RE: PETITION NO. 1690 - The Connecticut Light and Power Company d/b/a Eversource Energy petition for a declaratory ruling, pursuant to Connecticut General Statutes §4-176 and §16-50k, for the proposed Haddam Substation to East Haddam Junction Rebuild Project consisting of the replacement and reconductoring of electric transmission line structures along approximately 1.5 miles of its existing 115-kilovolt (kV) 1772 Line and 345-kV 348 Line shared right-of-way and associated Connecticut River crossing between Haddam Substation in Haddam and East Haddam Junction in East Haddam, Connecticut, and related electric transmission line and substation improvements.

Responses to Intervenor Interrogatories to Petitioner

Responses to CRGC Interrogatories to Petitioner – Petition 1690

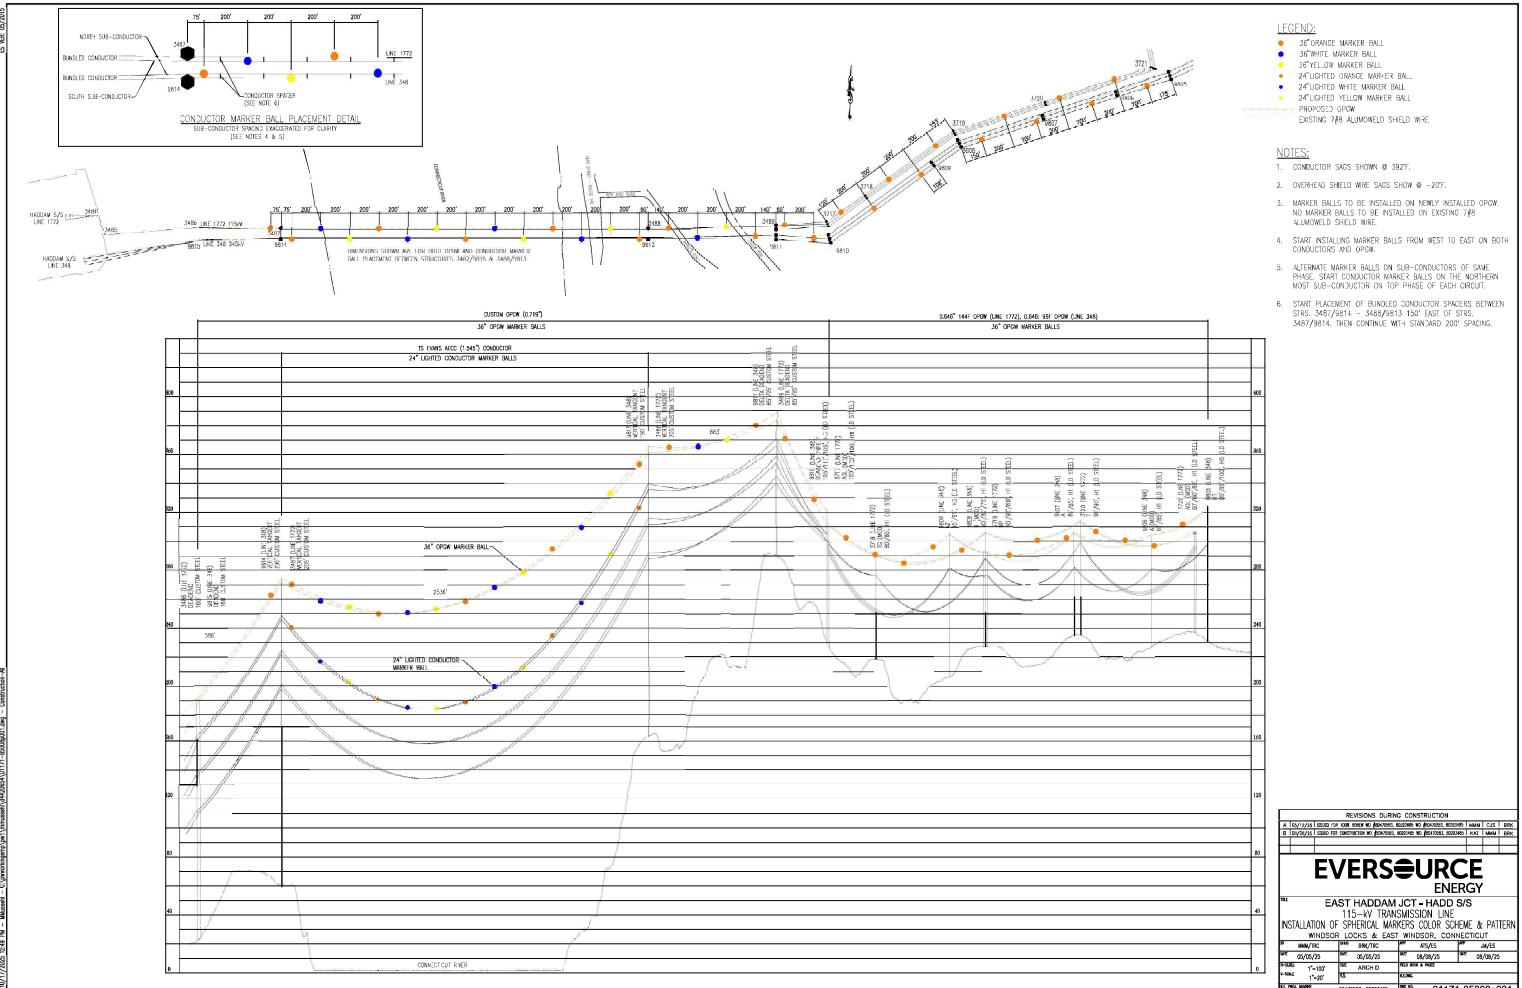
Question: Referencing Petition p. 26, provide the proposed marking/lighting plans and marker ball plans if available and describe how the plans comply with any FAA marking/lighting standards.

Eversource would meet the requirements of the FAA's determinations using FAA marking/lighting standards, as specified in FAA Advisory Circular 70/7460-1 – Obstruction Marking and Lighting. Since the Petition filing the number of lights and marker balls have changed slightly.

Details of the marker ball and lighting plan are provided in the attached drawing (CRGC-001-12 Attachment). The marker balls and lights for the Project are consistent with FAA marking/lighting standards based on marker ball size, placement, spacing, and color (refer also to the response to CRGC-001-Q13).
